Kewaunee / Point Beach Nuclear
Operated by Nuclear Management Company, LLC

NRC-02-108

December 19, 2002

Docket 50-305
Operating License DPR-43
Kewaunee Nuclear Power Plant
Response to Request for Additional Information Related to Proposed Revision to the Kewaunee Nuclear Power Plant Technical Specifications LAR 185, "Core Operating Limits Report"

Figure 2
Required Shutdown Reactivity vs Boron Concentration

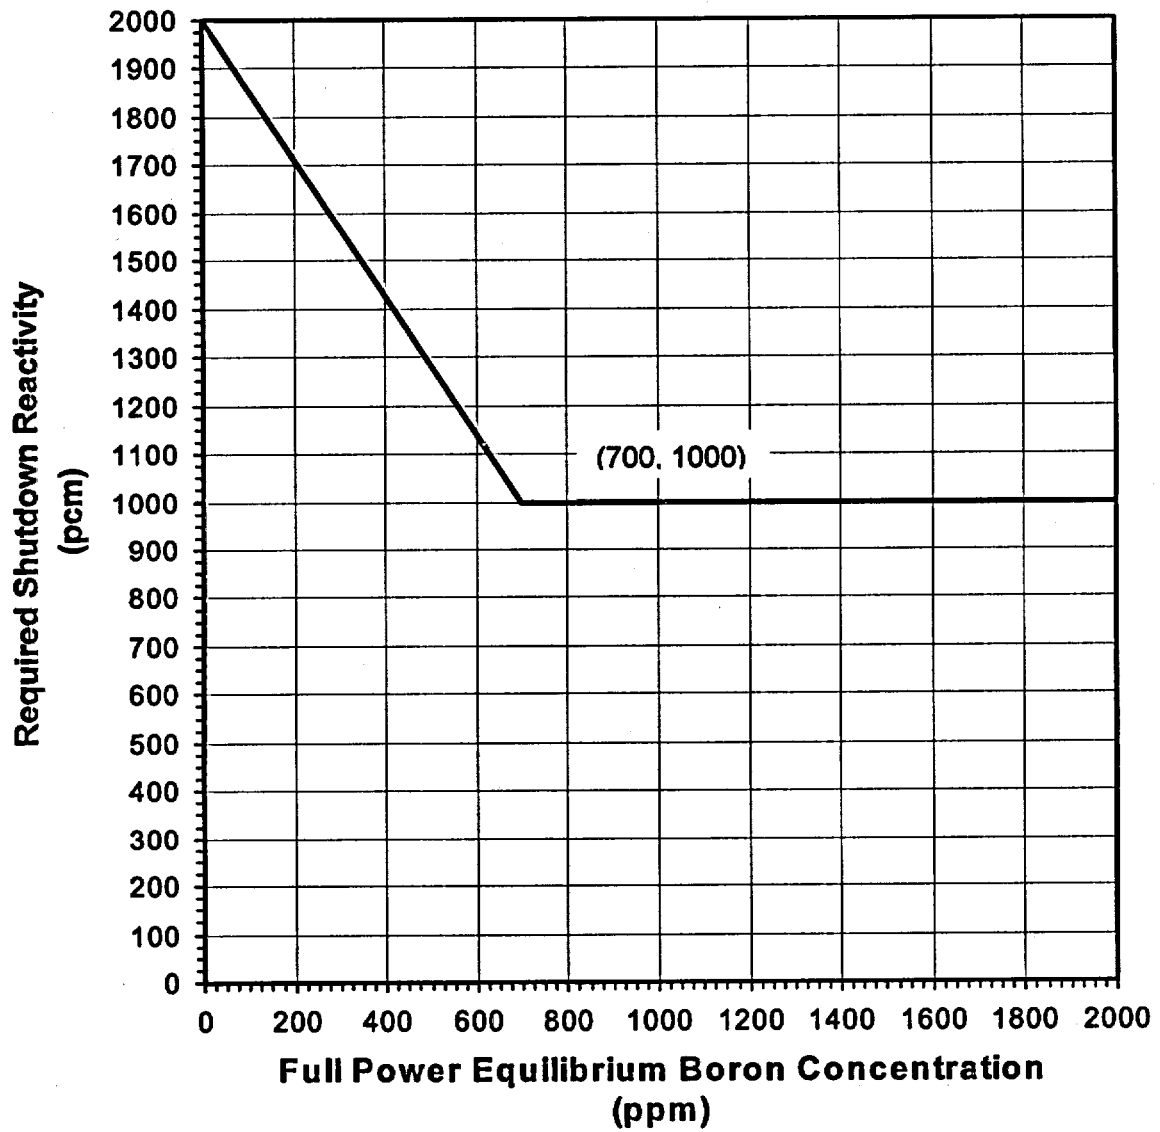
Your proposed Figure 2 of the COLR does not match the original Figure TS 3.10-1. Specifically, the required shutdown reactivity at 0 full power equilibrium boron concentration increased from 2000 pcm to 2200 pcm. Why is this change acceptable? Did you perform a 50.59 evaluation for this change?

This change from 2000 ppm to 2200 ppm is an administrative error. The limit of 2000 ppm is the correct value and the figure has been corrected in this submittal.
